**NAVAL AIR STATION, ALAMEDA
ALAMEDA, CALIFORNIA**

**REMEDIAL INVESTIGATION/FEASIBILITY STUDY
INTERIM REMOVAL ACTION, SITE 7A
BUILDING 459, NAVY EXCHANGE FUEL STATION**

**FIELD INVESTIGATION WORK PLAN
FINAL**

5.0 RESPONSE TO PUBLIC REVIEW AND REGULATORY AGENCY COMMENTS

FIGURE 3

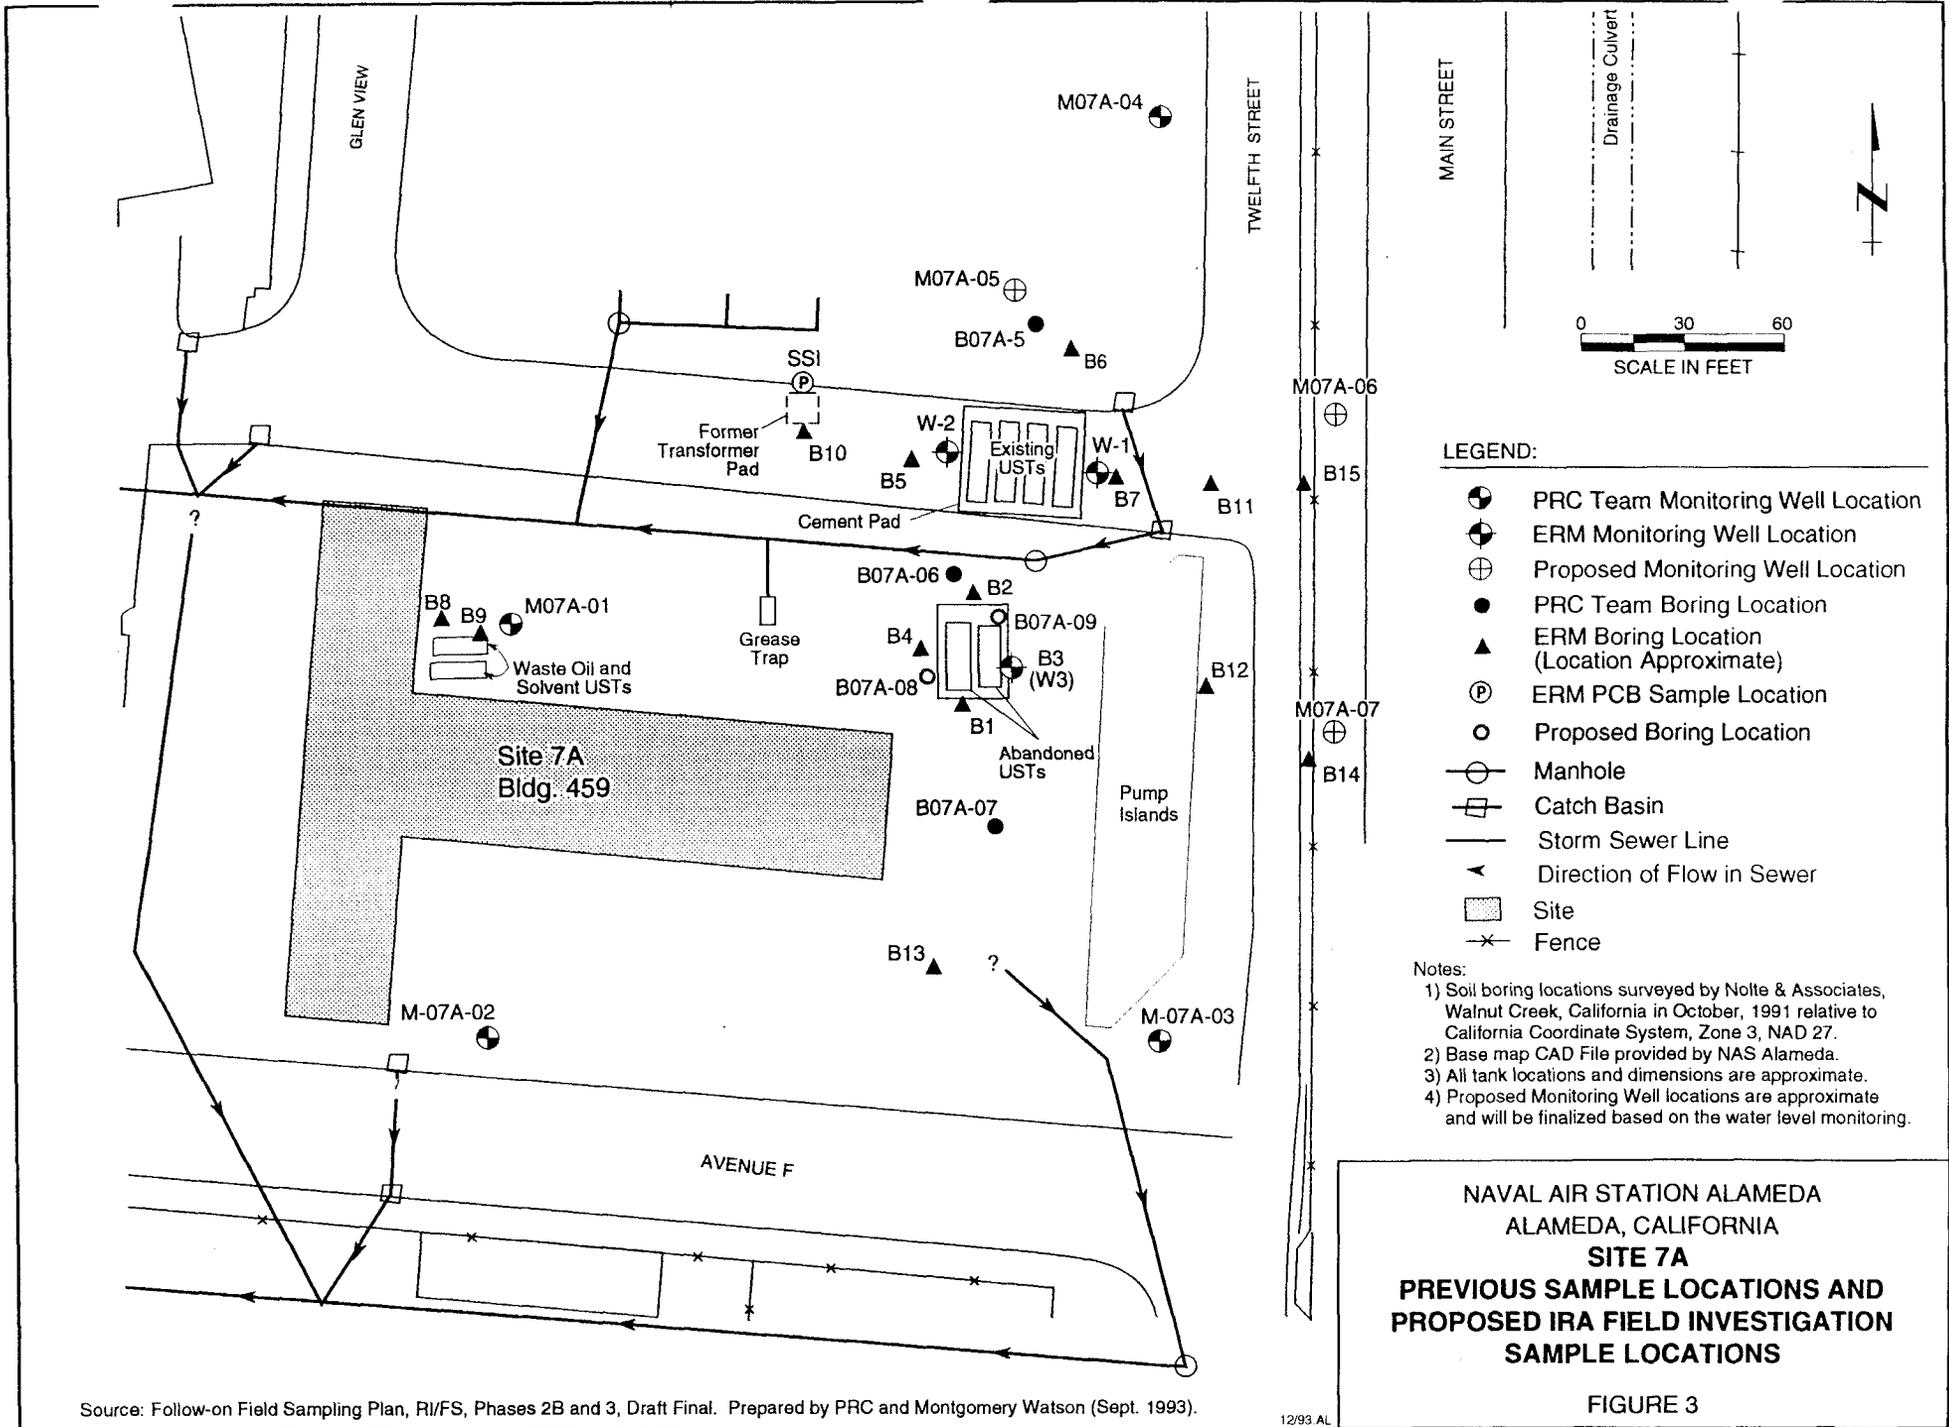
There needs to be an additional monitoring well directly west of the Existing Underground Storage Tanks (UST's). Both Total Petroleum Hydrocarbons (TPH), and Benzene, Toluene, Xylene, and Ethylbenzene (BTEX) have been detected in the groundwater at well point W-2. Another well is needed to the west of point W-2 (in the assumed upgradient direction) to see how far the plume extends in this direction.

Figure 3. Previous Sample Locations and Proposed IRA Field Investigation Sample Locations. An extra monitoring well is needed directly west of the four Existing UST's and the two Abandoned UST's (Please see General Comment #1). *Note: the text in the comment stating "...and the two Abandoned UST's" was later deleted by James Nusrala of RWQCB during a phone call on April 11, 1994.*

Although a well will be needed west of the existing USTs for closure at a later time, a well for the purpose of defining the extent of the plume (in effect, finding a "zero line") is not part of the scope of work of CTO 0262. The primary purpose of CTO 0262 is the collection of soil and groundwater information in preparation for source removal at the site. In addition, the upgradient direction cannot be assumed to be to the west of the existing USTs. Part of the purpose of CTO 0262 is to gather more water level information from the seven existing wells and one new well so that the groundwater gradient at the site may be better evaluated for the placement of two downgradient wells. Also, Site 7A is part of the basewide remedial investigation; future work at the site includes cone penetrometer testing and HydroPunch water sampling, which will generate additional information on the hydrologic characteristics of Site 7A.

Please see response to General Comment No. 1.

FIGURE 6

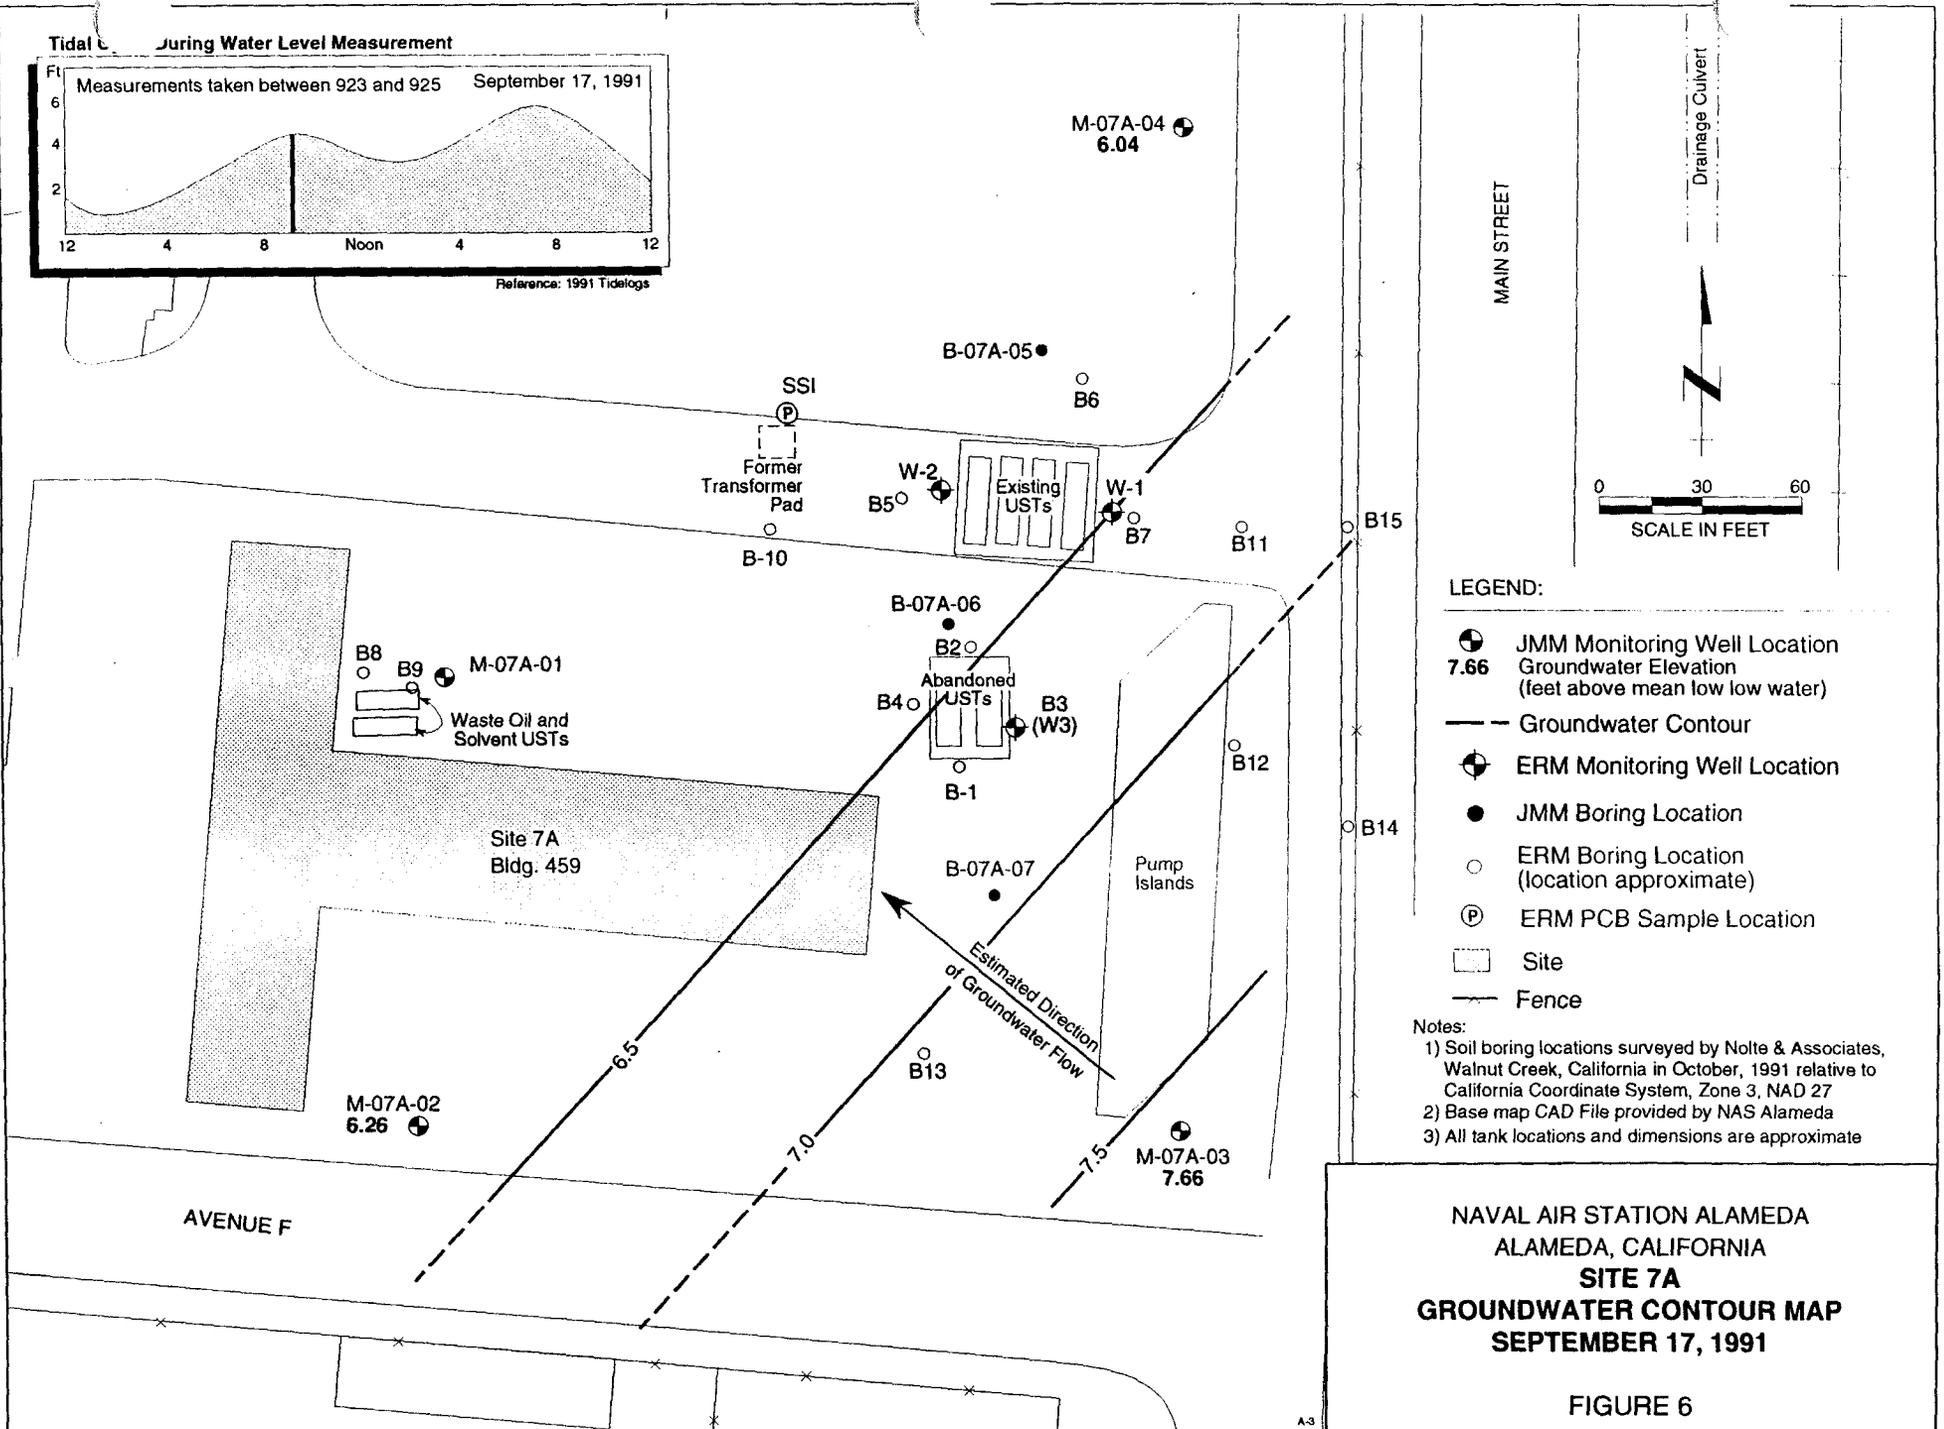
Comment No. 11: Given the uncertainty in groundwater flow direction, please include the figure showing eastward flow as well: Figure 8-6 of the Data Summary Report of 10/27/92, which displays data of 9/17/91.

Response: Figure 8-6 will be included as Figure 6 in this field investigation work plan.
